GO2-15-019
January 30, 2015

Subject: **COLUMBIA GENERATING STATION, DOCKET NO. 50-397
EMERGENCY LICENSE AMENDMENT ASSOCIATED WITH
TECHNICAL SPECIFICATIONS 3.5.1.A, 3.6.1.5.A, AND 3.6.2.3.A**

In accordance with 10 CFR 50.91(a)(5), Energy Northwest requests an Emergency Technical Specification Change for Columbia Generating Station (Columbia) for a one-time extension of the Completion Time of Technical Specification (TS) Actions 3.5.1.A, 3.6.1.5.A, and 3.6.2.3.A specifically associated with Residual Heat Removal (RHR) System B inoperability.

Figure 1 - Scope of Modification to Cross-Tie RHR to FPC

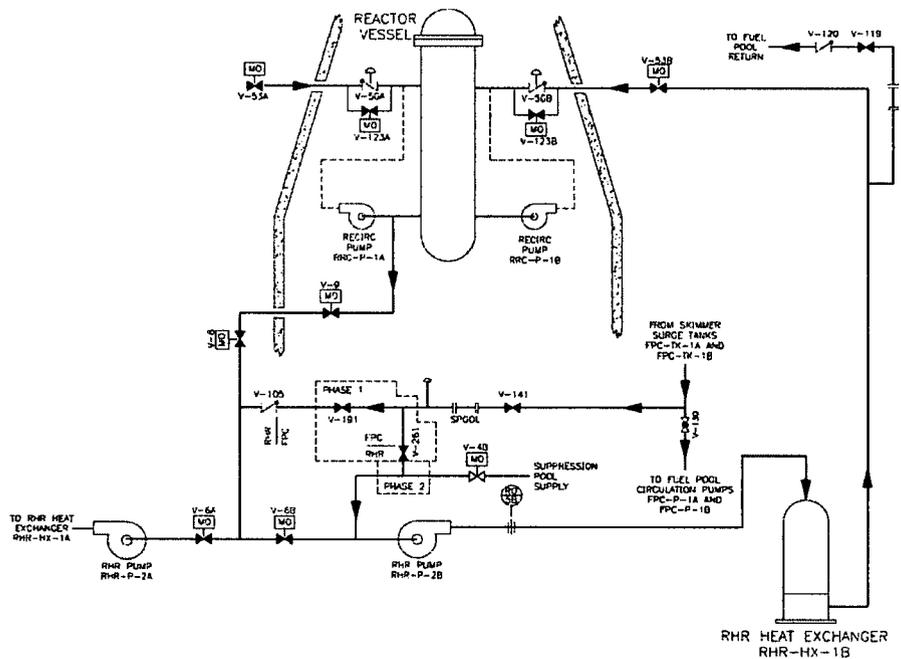
The implementation plan for this modification was designed in 2 phases, as depicted in Figure 1, to minimize the time during which RHR Loop B would be required to be inoperable. Phase 1 of the modification was previously completed and the existing RHR-B outage is associated with Phase 2. Phase 2 specifically involves cutting the 24" RHR Loop B suction side piping and welding a new pipe section connecting to the 10" FPC piping installed in Phase 1. The time required for completion of the work required in Phase 2 was estimated to be approximately 4 days.
